# "SIMPLE SOLUTIONS FOR '98"

## INTRODUCTION

***AUTOMATIC TRANSMISSION SERVICE GROUP***  
9200 S. DADELAND BLVD.  
SUITE 720  
MIAMI, FL 33156  
(305) 670-4161

Figure 3

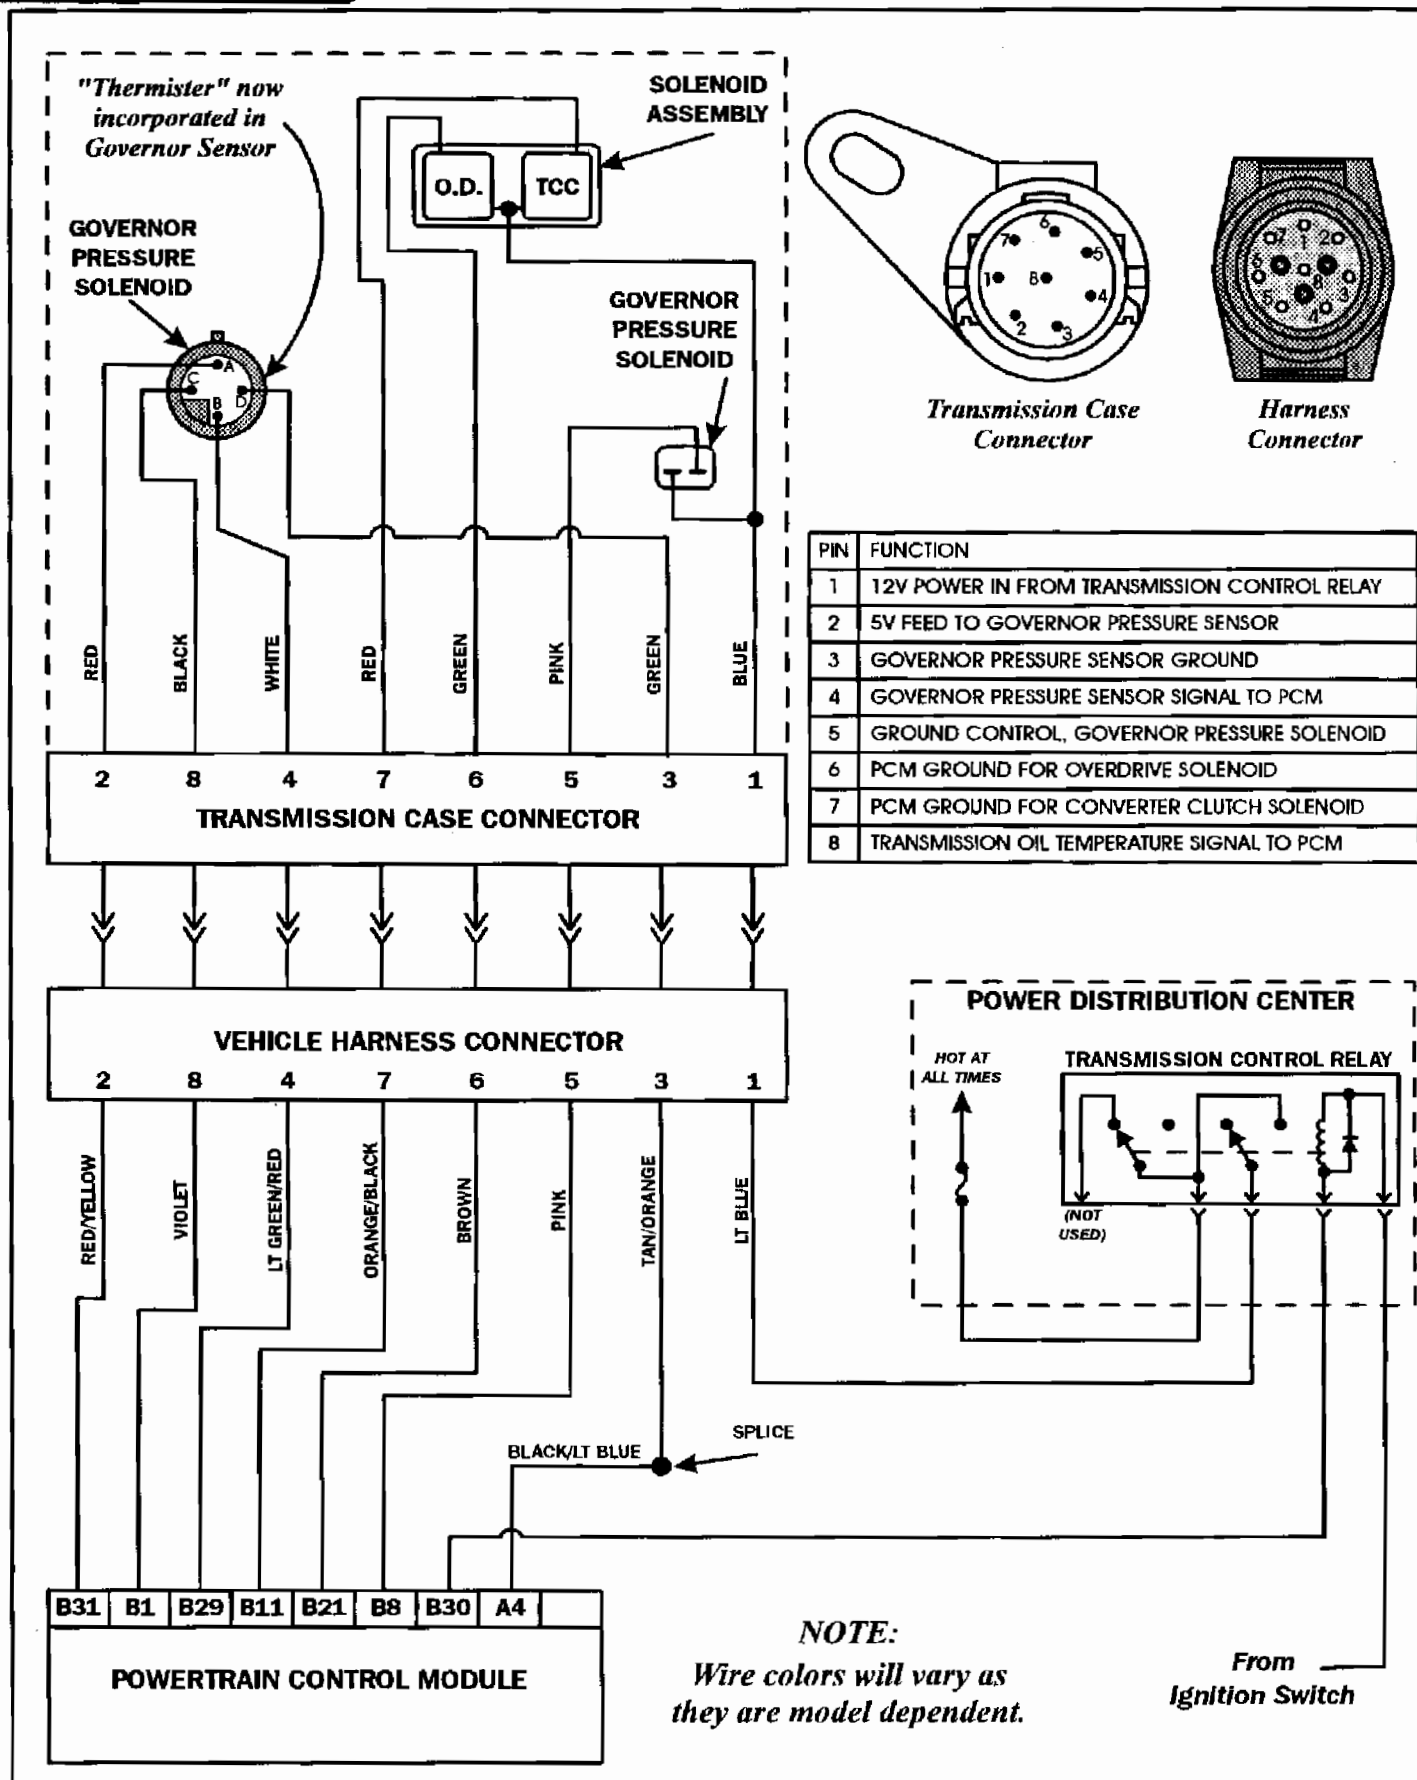
*Change No. 2* - Beginning at the start of production for 1996 models, all Chrysler vehicles equipped with a 42RE, 44RE, 46RE or 47RE transmission were built with a Powertrain Control Module (PCM), instead of the previous Transmission Control Module (TCM). Chrysler has installed a new "Transmission Control Relay" on these models that now controls the voltage to pin number one at the transmission, via a ground signal from the PCM. Refer to Figure 2 for locations and wire colors on the various models, and Figure 3 for a complete wiring schematic including the Transmission Control Relay.

Figure 3

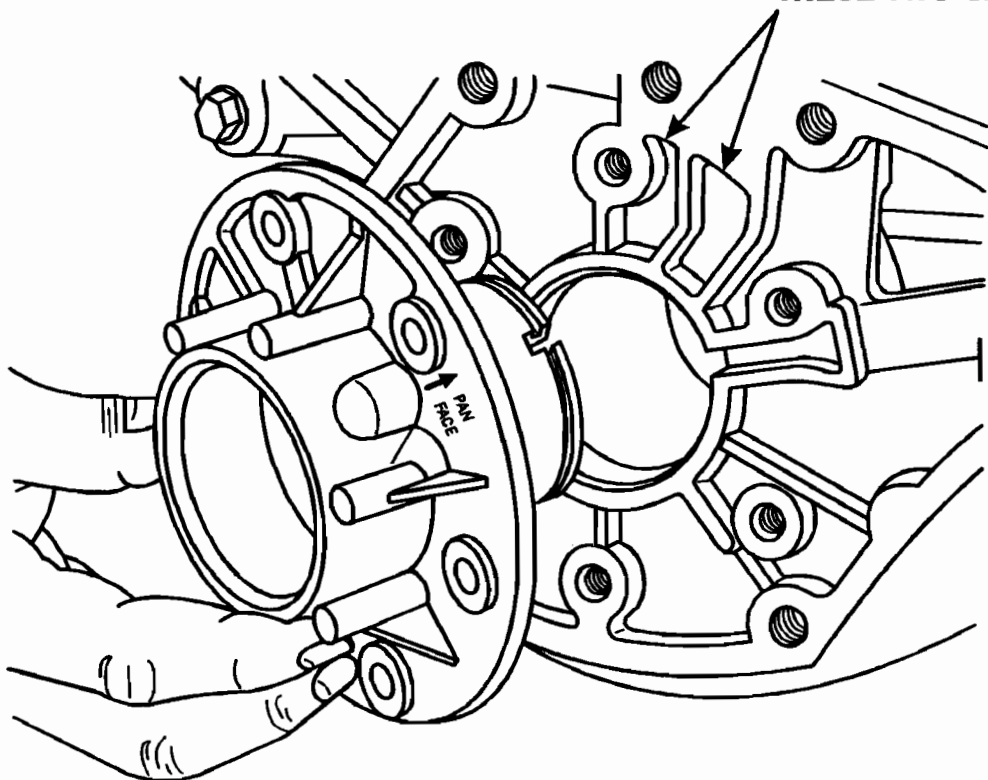
**CAUSE:** The cause may be, the Governor Support installed into the case incorrectly.

**CORRECTION:** The late model Chrysler A904/A999 transmissions have a Governor Support with the mounting holes evenly spaced, or concentric around the support, which will now allow you to install the Governor Support so that the governor feed passage is blocked. Some Governor Supports have an arrow with the words "PAN FACE" cast into the support as shown in Figure 2, and should be installed with the arrow towards the pan face. If your support is not so marked, make your own reference marks on the support and the case with a center punch as shown in Figure 1, before removing. If you have already removed the support, and your support is not marked with the arrow, the support must be installed into the case with the feed holes lined up with the corresponding case passages, as shown in Figure 3.
